Subject: 10CFR21 Reporting of Defects and Non-Compliance -
Engine Systems, Inc. Report No. 10CFR21-0123, Rev. 1

EMD Fuel and Soakback Pumps – Potentially Undertorqued Cover Bolts

Report No. 10CFR21-0123

Rev. 1: 12/21/18

Figure 1: Exploded View of Pump P/N 8410219

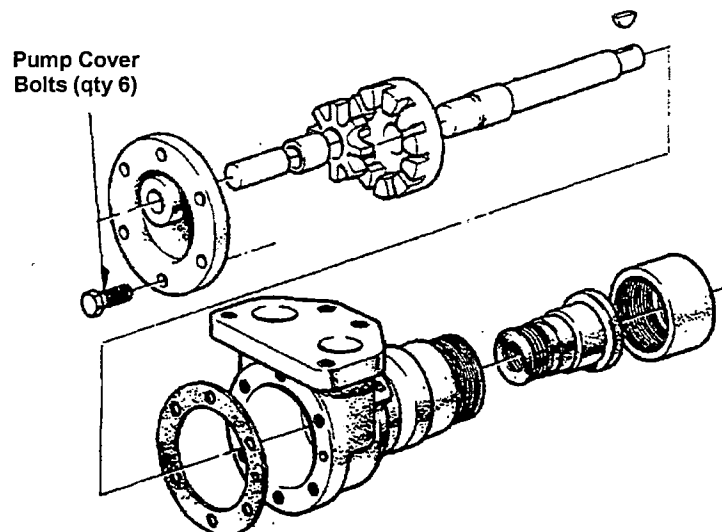
ESI was notified by a nuclear customer of two instances where a bolt was found loose or backed out of the cover of an EMD engine driven fuel pump P/N 8410219. Following notification, ESI inspected remaining pumps in inventory and found instances where one or more the pump cover bolts were loose or lightly torqued. See Figure 1 below for a visual depiction of the pump and bolts.

ESI recommends inspecting the bolt tightness for all pumps. The recommended bolt torque is 108 to 120 in-lbs (12 to 13 Nm). After verifying bolt torque, a shaft freeness check is recommended. The pump shaft should be capable of being rotated by hand in either direction. Due to the small shaft size, this check is commonly performed with a small crescent wrench or with the coupling half installed on the shaft. Inability to rotate by hand indicates loss of end clearance and the pump should be returned to ESI for rework or replacement.

Note: For installed pumps where it is not possible to check shaft freeness, ESI recommends using a reduced bolt torque of 60 to 70 in-lbs (7 to 8 Nm). This is sufficient to ensure the bolts are snug while safeguarding against loss of end clearance that would otherwise go undetected.
